**Committee:** Planning Committee  
**Date:** Thursday 8 September 2022  
**Time:** 4.00 pm  
**Venue** Bodicote House, Bodicote, Banbury, Oxon OX15 4AA

### 8. **Development Brief for Local Plan Partial Review site PR6a – Land East of Oxford Road, North Oxford** (Pages 10 - 170)

Figure 21: Green infrastructure

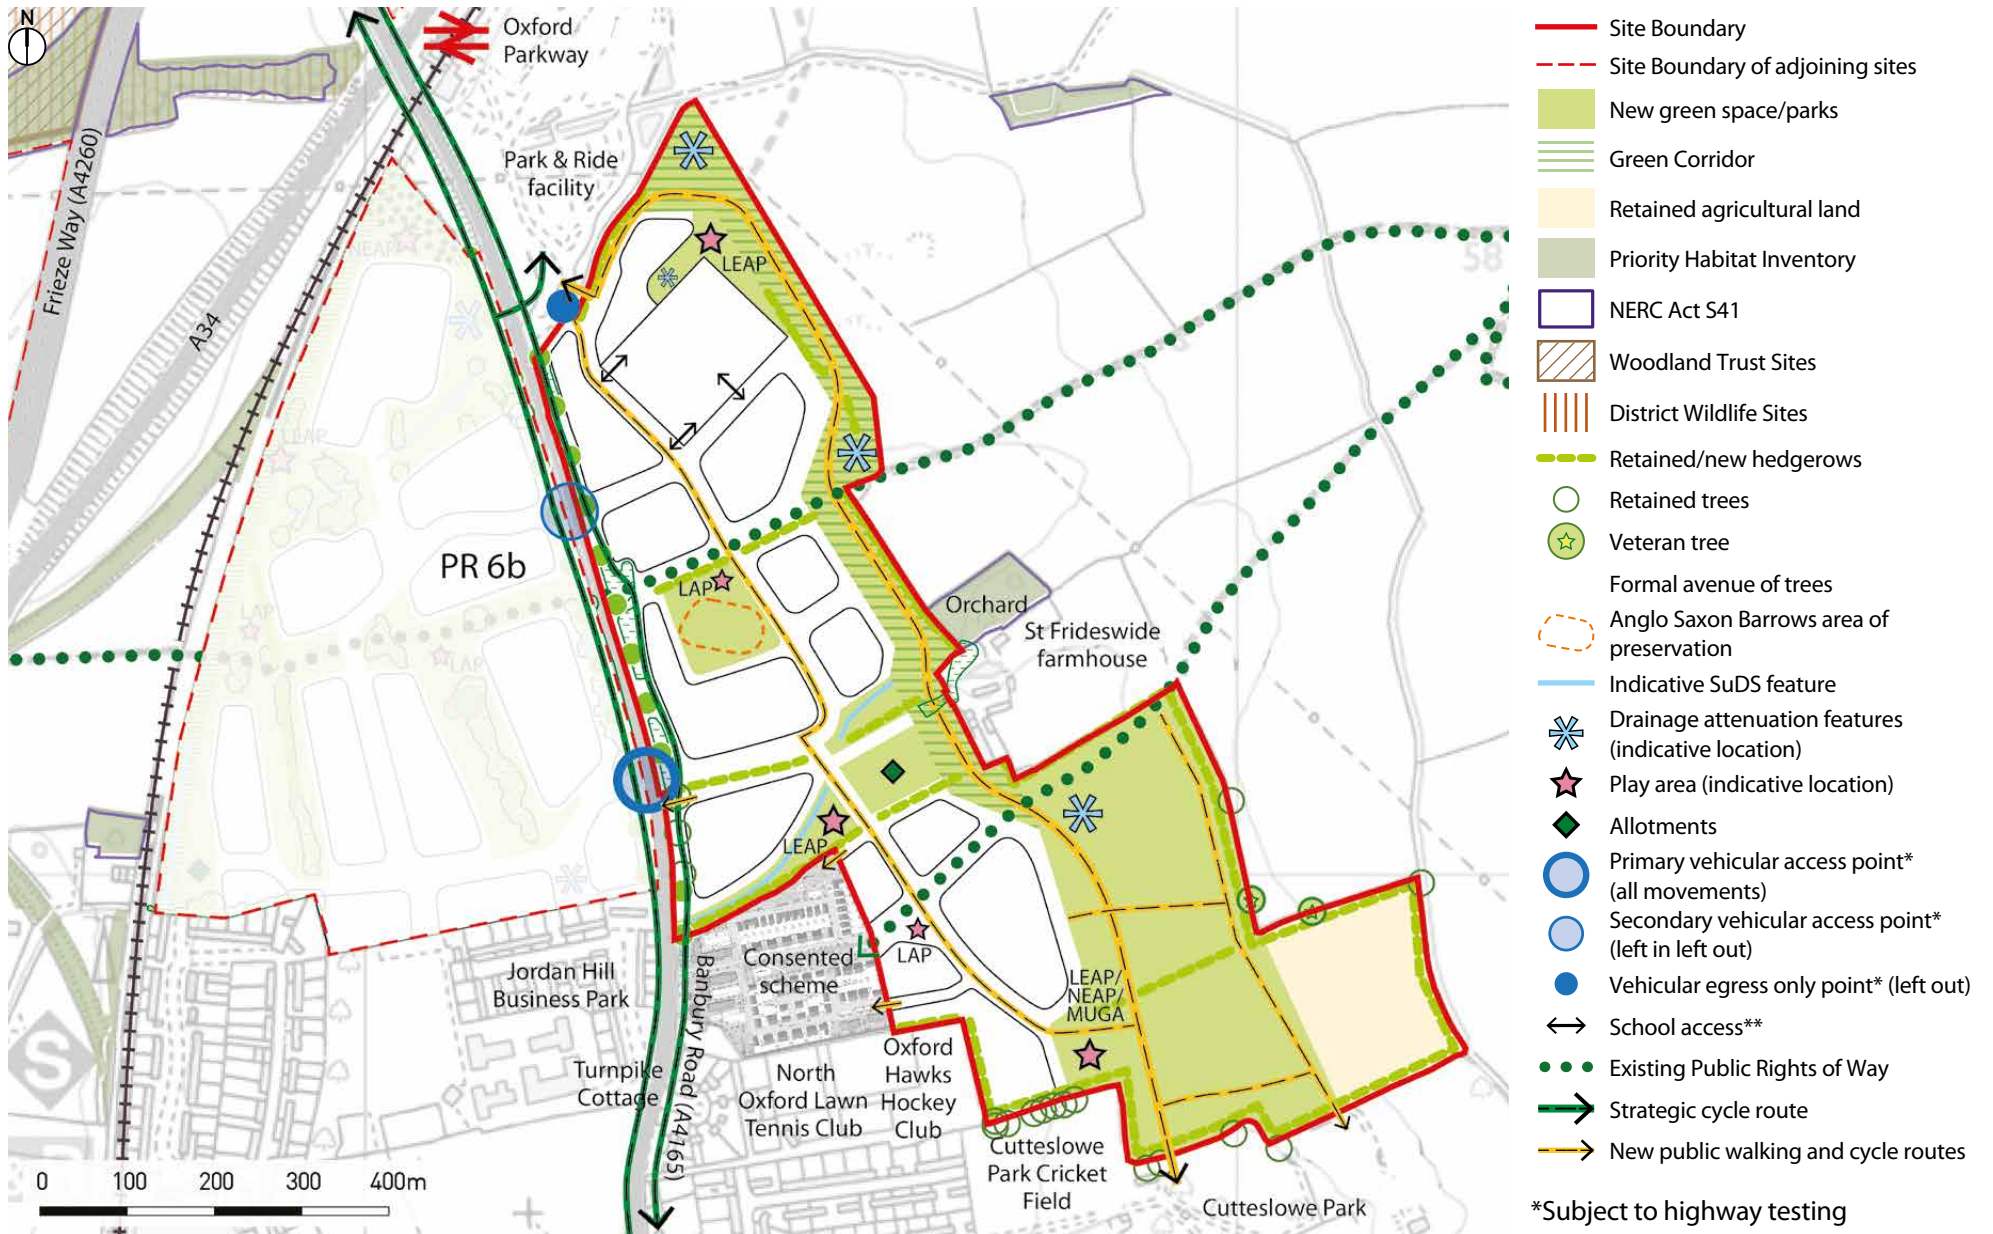
Savills (land promoter)	<p>Fig 21. The Croudace scheme should be shown in outline on the plan (like the PR6b development blocks).</p> <p>The area shown below is identified in Figure 1 (Development Framework) as 'residential'. Please refer to comments made in relation to this Figure, in particular the request that a development perimeter block is identified in this location.</p> <p>This figure does not include a green corridor that would accommodate the diversion of the existing overland surface water flow route displaced by the school.</p>	Noted - the appropriate figures should be updated to reflect this approved layout for the Croudace development. In relation to the allotments, see earlier comments. The green corridor is shown so it is unclear as to what this comment relates.	The appropriate figures will be updated to reflect this approved layout for the Croudace development	Croudace layout added to plans

Savills (land promoter)	<p>6.5.2 Blue infrastructure (Page 55)</p> <p>Development Principles, Bullet 2: Drainage attenuation features are shown on Figure 21 not 19.</p> <p>Typo, the words 'area and' are missing from bullet point which should read "...the residential developable area and outside.. " (replace 'outside' with these words).</p>	Noted	Page 55, 2nd bullet - change 'figure 19' to "figures 15 and 21". "Oxfordshire County Council Drainage Team" to be amended to "lead local flood authority". Page 56, 2nd bullet - change "outside and outside" to "area and outside"	Text of 55 as per OCC comment below and 56 amended
Savills (land promoter)	<p>6.5.3 Green Belt (Page 56)</p> <p>Second Paragraph: Clarification is required as to what is meant in terms of enhancements to the setting of St Frideswide Farmhouse?</p>	It is considered that the words after 'open space' are not necessary and can be removed	Page 56, 2nd para under Green Belt - remove the words "including enhancements to the setting of St Frideswide Farmhouse".	Text deleted from 6.5.2

- page 55, 2nd bullet - change 'figure 19' to "figures 15 and 21". "Oxfordshire County Council Drainage Team" to be amended to "lead local flood authority". Page 56, 2nd bullet - change "outside and outside" to "area and outside"

- the appropriate figures have been updated to reflect this approved layout for the Croudace development
- text of section 6.5 has been amended, but reference to land outside the allocated boundary has not been included as this is outside the remit of the development brief
- reference to the aggregate rail depot has been added to figure 10 and section 4.1
- section 4.2.5 - the 2nd bullet point has been amended to read: "Opportunity to integrate the site layout with adjacent development sites including PR6b and movement links outside the site including an onwards link to the Oxford North site via high quality crossing of Oxford Road and the rail line, and an onward link over the A40 via the existing bridge adjoining Cutteslowe Park. Regard should be had to published guidance including the Oxford and Kidlington Local Cycling and Walking Infrastructure Plans."
